WORK DESCRIPTION FOR FIELD MEASURE

Code: 19P6190004

Replace heat shield of exhaust system

Model 205

Figure 1

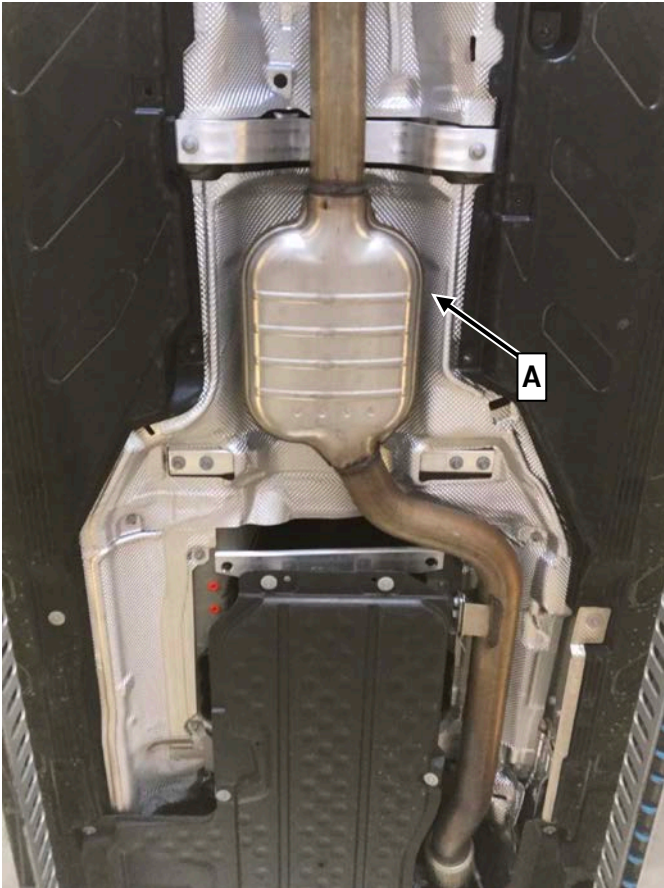
1. Replace heat shield (A, Figure 1) of exhaust system .

i Partly loosen the side underfloor paneling and lower the exhaust system slightly.

Quantity	Designation	Part no.
1	Shield	A 205 682 40 00
